NUCLEAR LOGISTICS INC

Letter #QA-2044

Subject: 10CFR21 notification

Technical Bulletin TB-0948431-02 PCP Firing Board P.C. Assemblies

Figure 1

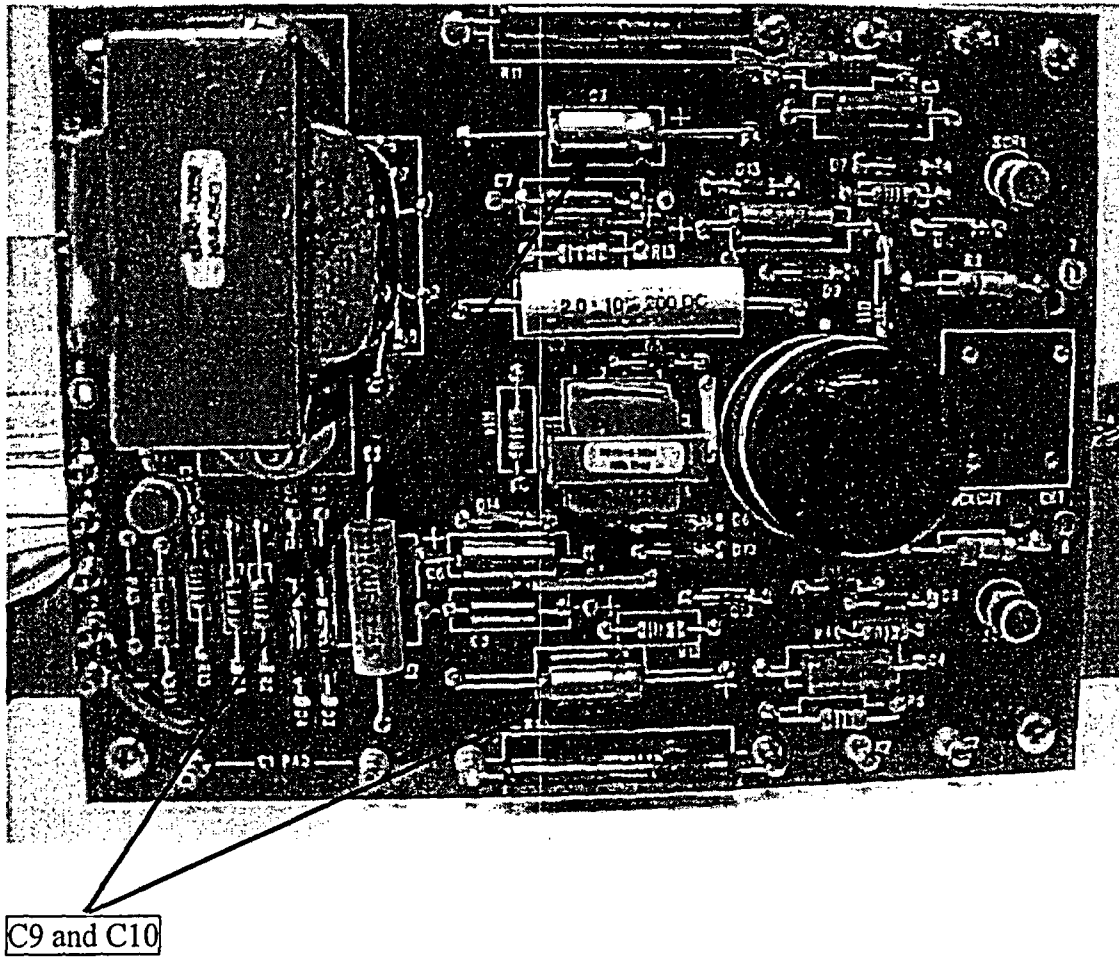
The capacitors are identified as Vishay 109D silver cased wet tantalum electrolytic capacitors. They are used in the C9 and C10 position on the 3 tiers of the printed circuit assembly (6 capacitors total). The circuit boards with the underrated capacitors will fail prematurely. The accelerated degradation of the capacitors is due to the level of the ripple current on the firing board.

- Examine C9 and C10 on all three tiers of the firing board assembly (6 capacitors total) as follows:
 - Inspect the C9 and C10 capacitors (refer to figures 1 and 2 for location and identification). The capacitors with the shortened life are labeled with 109D. If the capacitors are labeled other than 109D, they are acceptable and the circuit board can be used.
 - While examining the circuit boards, inspect the capacitors for evidence of degradation (yellow color or black/brown burn spots). Discoloration is a

Firing board assemblies with capacitors labeled 109D should be returned to NLI for rework and retesting. As an alternative, NLI can supply the replacement capacitors for installation on the circuit board by the plant.

Figure 2

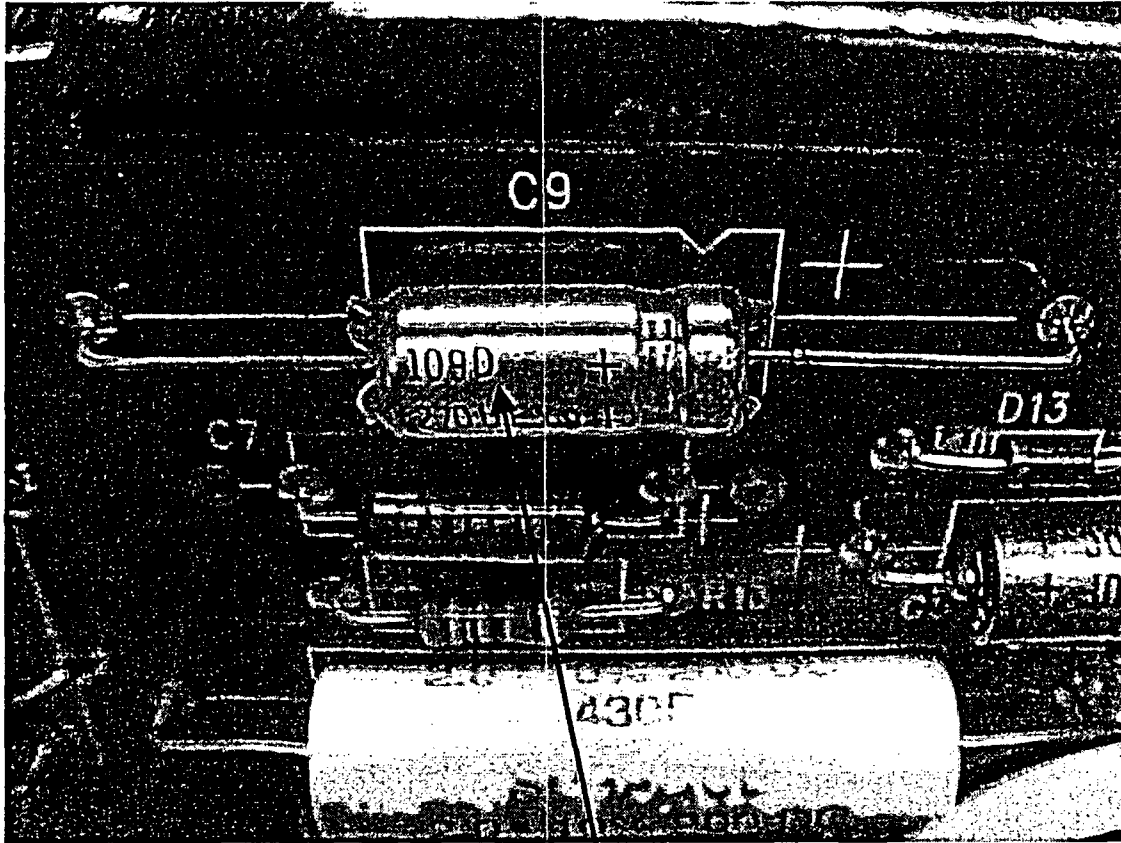
Note case markings
